# Access Compliance Report

### (Curb Ramps)

Intersection ID: 50578	Main Street: PAPER_TREE_RD	Cross Street: BENDING_BRANCH_RD	Location: E
ADA ID: 0E4D98AB3098	Ramp Type: Perp	Initial Pass/Fail: Fail	Overall Compliance: No
Severity Score: 8.75			
Codes/Mitigation Info/Possible Solution		Field Measurements/Component Compliance

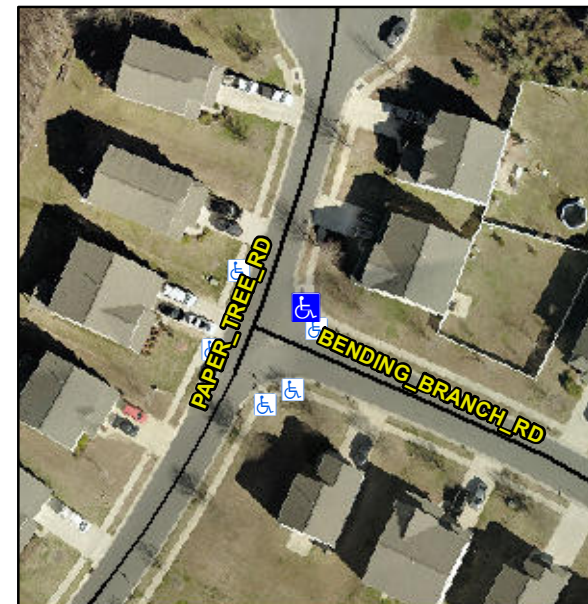
**Not Found, R304.5.1**

Compliance	Description	Data	Compliance	Description	Data
N/A	Ramp Length (in)	47.0	Yes	Ramp Slope (%)	8.0
No	Ramp Width (in)	47.0	Yes	Ramp XSlope (%)	1.8
N/A	Flare Type LT	N/A	N/A	Flare Type RT	N/A
N/A	Flare Slope LT (%)	N/A	N/A	Flare Slope RT (%)	N/A
N/A	Flare Traversable LT?	N/A	N/A	Flare Traversable RT?	N/A
N/A	Landing Length (in)	N/A	N/A	DWS Provided?	N/A
N/A	Landing Width (in)	N/A	N/A	DWS Contrast?	N/A
N/A	Landing Slope (%)	N/A	N/A	DWS Length (in)	N/A
N/A	Landing X Slope (%)	N/A	N/A	DWS Full Width?	N/A
N/A	Landing Curb? (Y/N)	N/A	N/A	DWS Offset (in)	N/A
N/A	Shared Landing?	N/A			
N/A	Gutter Ponding?	N/A	N/A	Gutter Slope (%)	N/A
N/A	Gutter Lip Ht (in)	N/A	N/A	Gutter X Slope (%)	N/A
N/A	Painted X Walk1?	No	N/A	Painted X Walk2?	N/A
	X Walk 1 Direction	To NW		X Walk 2 Direction	N/A
N/A	X Walk 1 Width (in)	N/A	N/A	X Walk 2 Width (in)	N/A
	X Walk 1 Slope (%)	2.5		X Walk 2 Slope (%)	N/A
	X Walk 1 X Slope (%)	1.8		X Walk 2 X Slope (%)	N/A

**Remove & Replace Entire Ramp.**
